**Re: Azar-Menaul Townhomes, Grading and Drainage Plan  
Engineer's Stamp Date 5/17/2015 (H22/D078)**

Based upon the information provided in your submittal received 5-17-15, the grading and Drainage Plan is approved for Building Permit, Grading Permit, and SO-19 Permit. Please attach a copy of this approved plan to the construction sets prior to sign-off by Hydrology.

**Subject:** FW: Indian Ridge Subd.

Rudy, Please find the responses to your written comments dated 5/12/16. The initial comments area in black and our response as to how we addressed are in blue:

ENGINEER'S SEAL    4/21/16 5/17/16  DAVID SOULE P.E. #14522	TRACT 2-A INDIAN RIDGE SUBDIVISION	DRAWN BY JDG
	GRADING AND DRAINAGE PLAN	DATE 11-16-2015
  1606 CENTRAL AVENUE SE SUITE 201 ALBUQUERQUE, NM 87106 (505) 872-0999	SHEET # DRB 03	JOB #

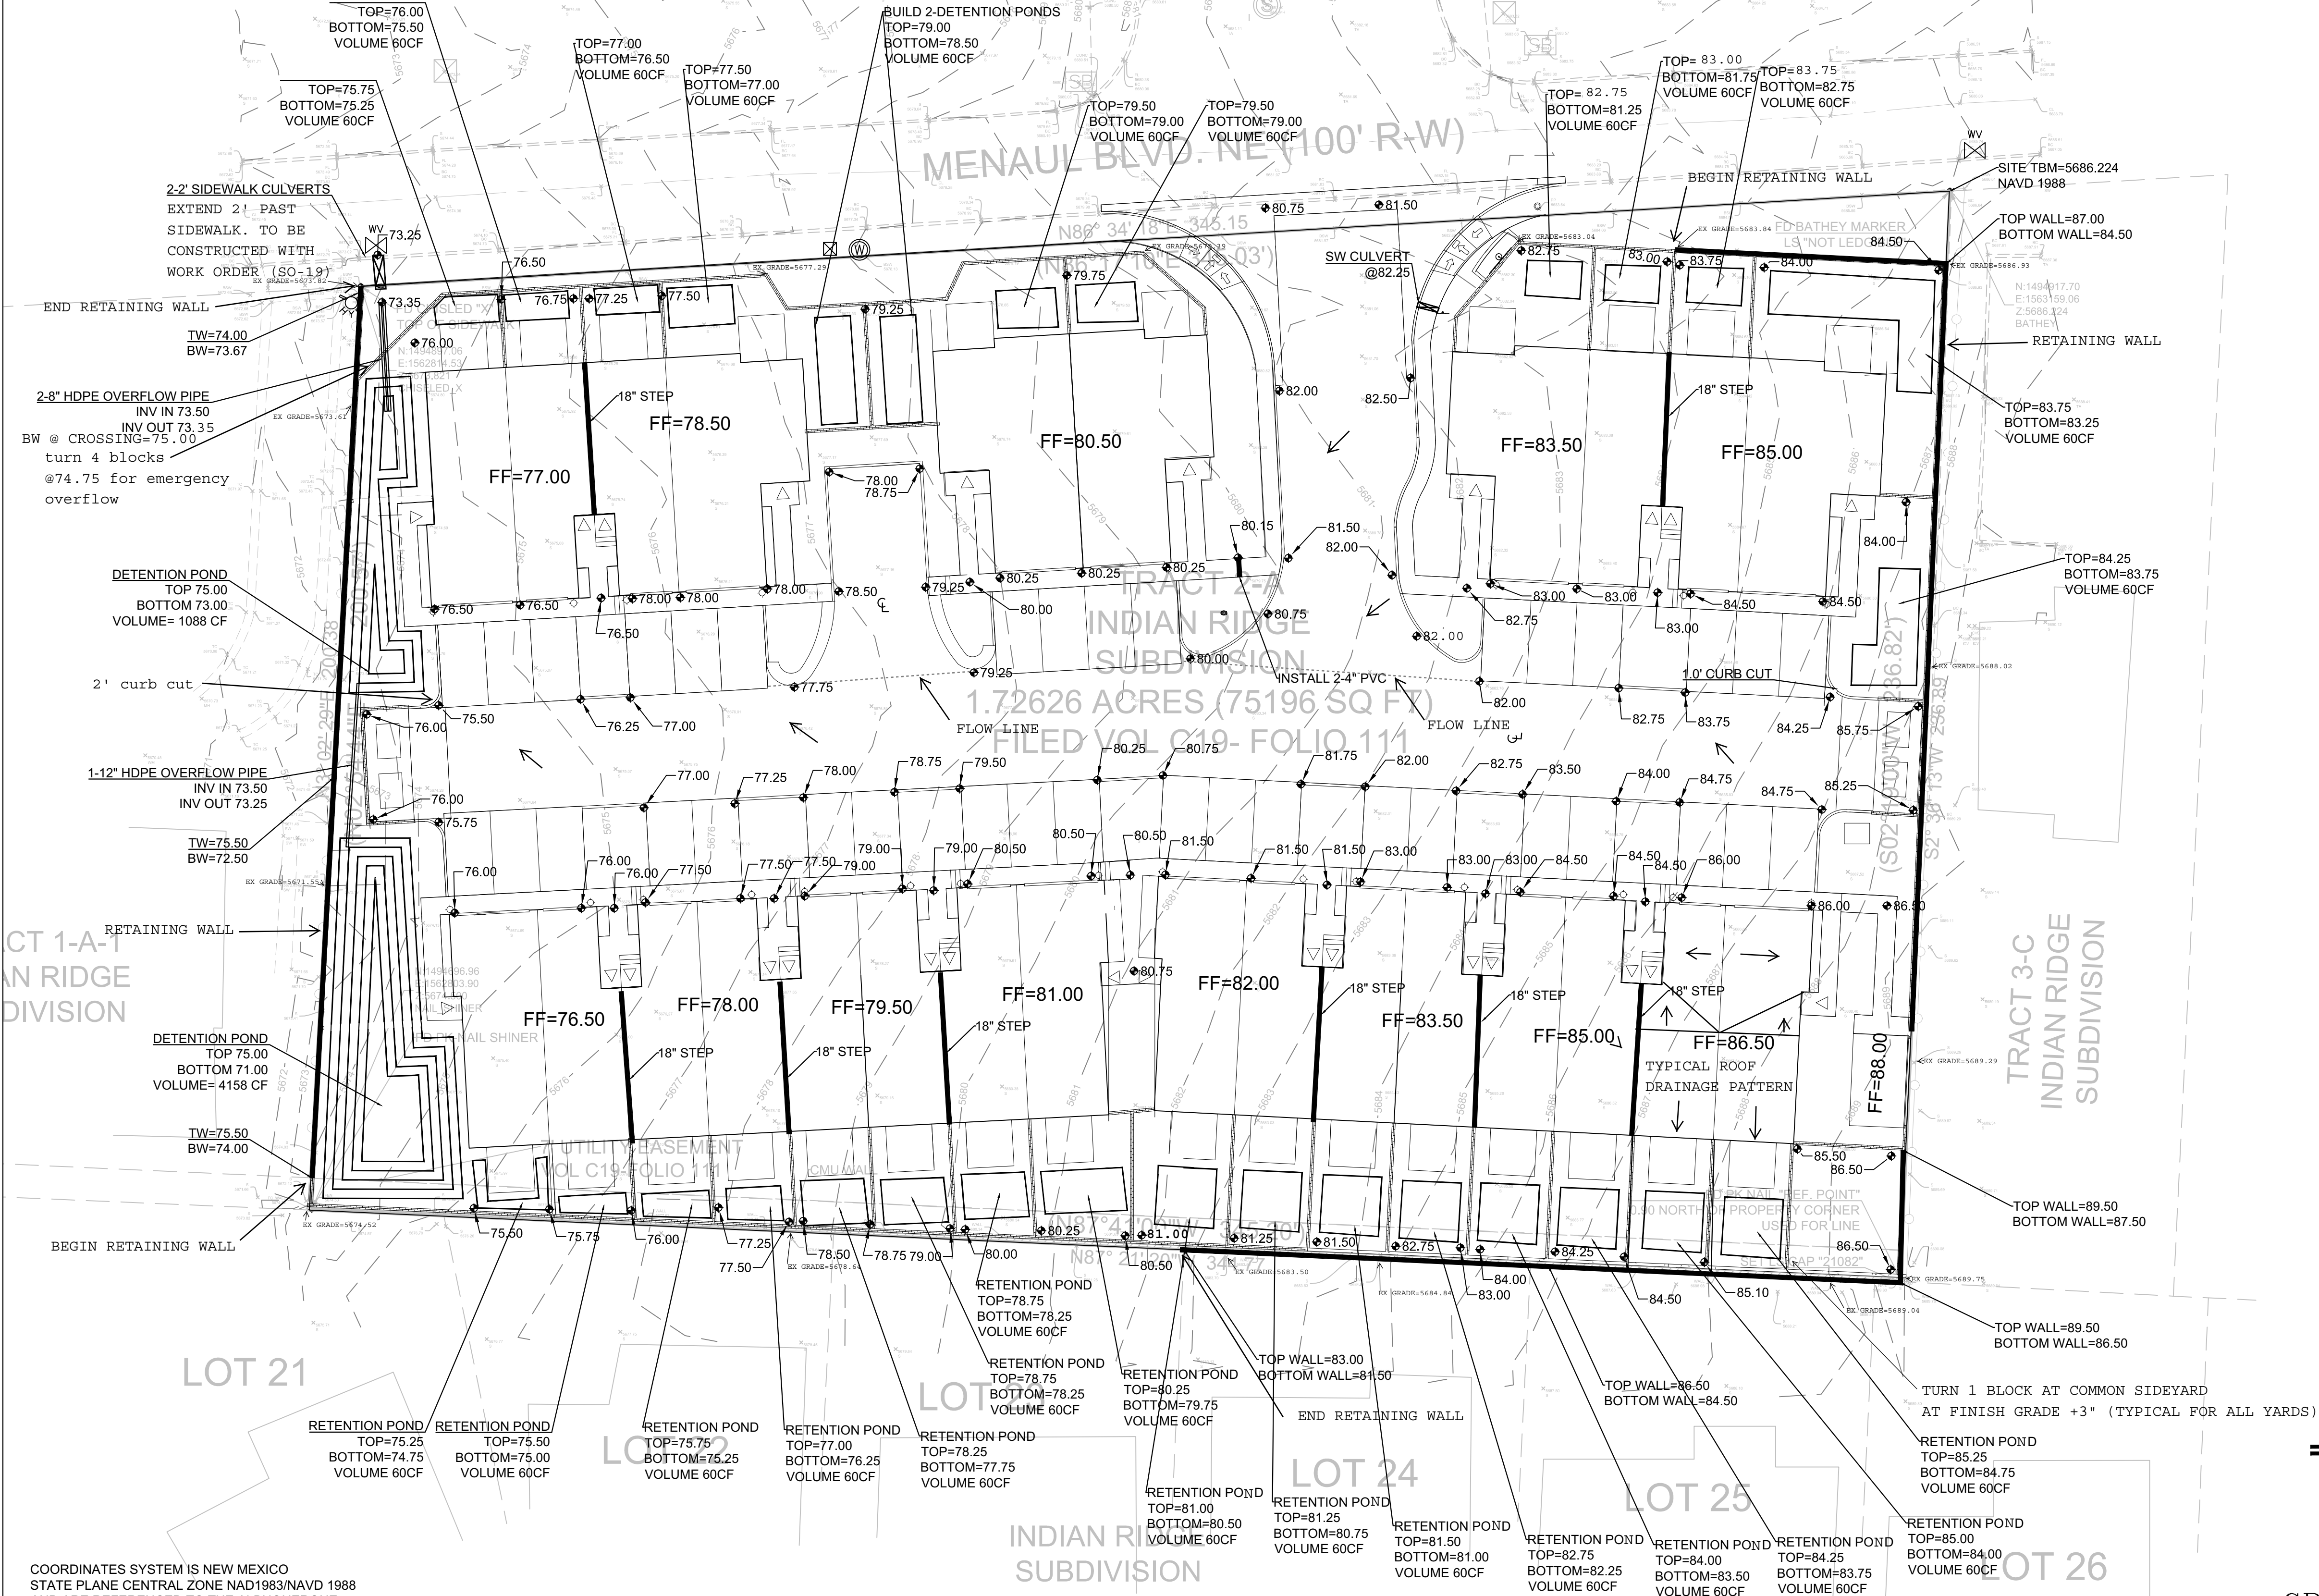
- There are some darkened lines throughout the site, are these all retaining walls?  
**YES, I HAVE ADDED LABELS TO CLARIFY, WE HAVE TOP AND BOTTOMS CALLED OUT**

- Provide a detail for all retaining walls.  
**I HAVE ATTACHED, THESE ARE PART OF SEPARATE PERMIT**
- How will flows leave the back yards? Provide turn blocks 3" above grade.

**WE HAVE ADDED TO NOTE TO PLAN AND ADDED TO NOTE#3**
- Provide a detail where the block wall and the 8" HDPE intersect each other.  
**I HAVE ADDED NOTE TO PLAN TO CLARIFY THE PIPE RUNS UNDER WALL  
BOTTOM OF WALL=75.00, TOP OF PIPE=74.00**

- Provide elevations around the exterior of the perimeter.  
**I HAVE ADDED**
- Show roof flows.  
**THE ROOFS ARE PITCH SO I HAVE ADDED ROOF DRAIN PATTERN ON SE BUILDING  
AND LABELED AS  
TYPICAL**

- Provide a note requiring a separate permit for all walls is required.  
**I HAVE ADDED AS NOTE#4**
- Show the extension of the sidewalk culvert 2 feet passed the property line.

**I HAVE CORRECTED THE DRAWING TO BE GRAPHICALLY CORRECT**
- The NW corner of the sites spot elevation is higher than the invert out, please correct.  
**WE HAVE CORRECTED THIS TYPO.**
